2007 - 2013 Cadillac CTS-V: GM TechLink: Low Oil Pressure on V8 Engines

Subject: Low Oil Pressure on V8 Engines

Model and Year: 2007 - 2013 CTS-V, Escalade, Avalanche, Camaro SS, Colorado, Corvette, Express, Silverado, Suburban, Tahoe, Canyon, Sierra, Savana, and Yukon models equipped with a V8 engine (RPOs L20, L77, L94, L96, L99, L9H, LC8, LC9, LH9, LMF, LMG, LY6, LZ1)

Fig. 3

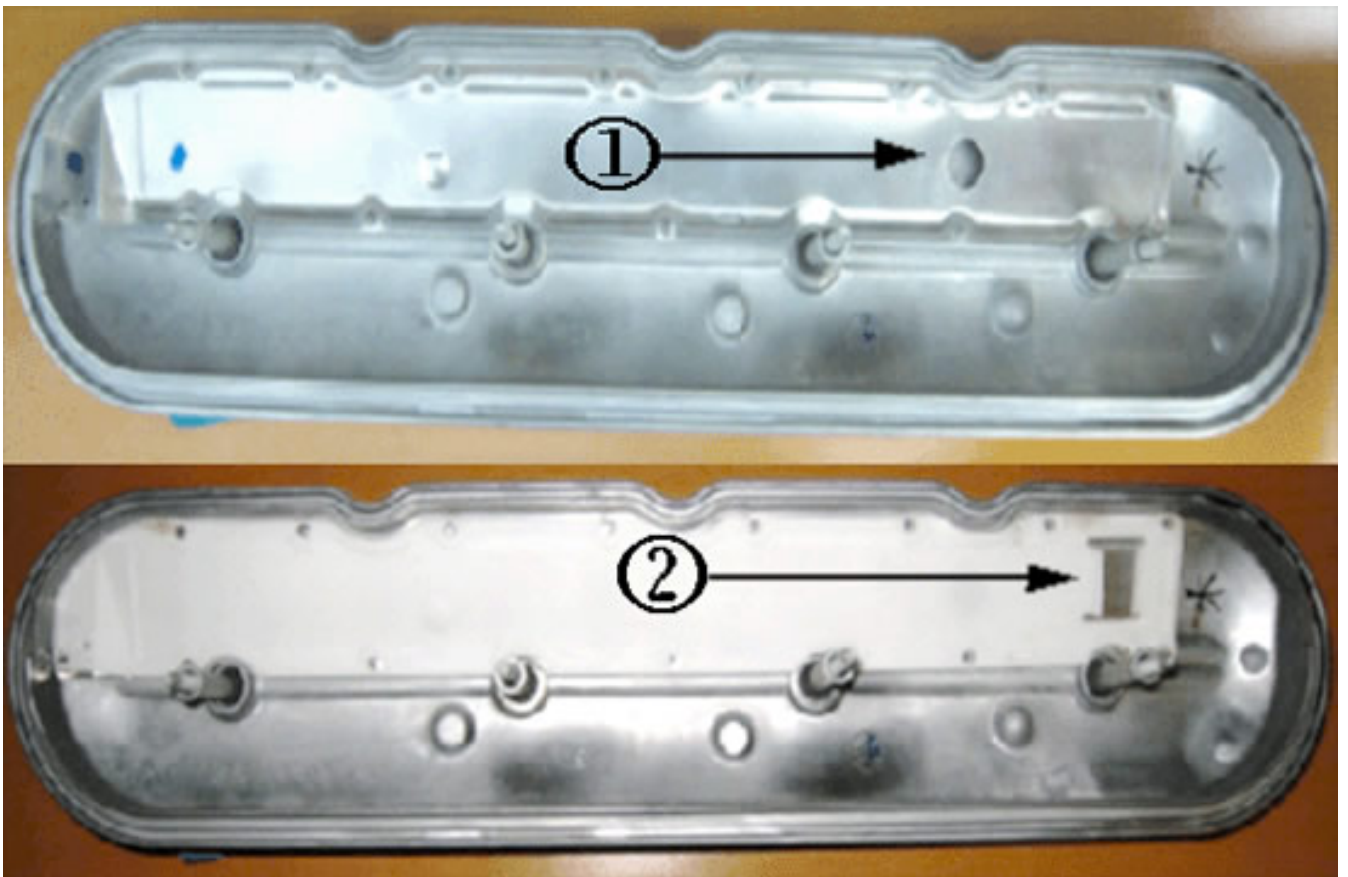
If the engine has been properly repaired and cleaned, inspect the left rocker cover (square baffle) (Fig. 3, #1 – old design; #2 – new design with square baffle) and verify that the baffles can hold water and do not leak. If any leaks

are found, clean and seal the edge of the baffle with RTV, if possible, or replace the valve cover. Thoroughly clean and dry the valve cover before installation and/or resealing.

In addition, change the engine oil and replace the oil filter with a PF48E filter.
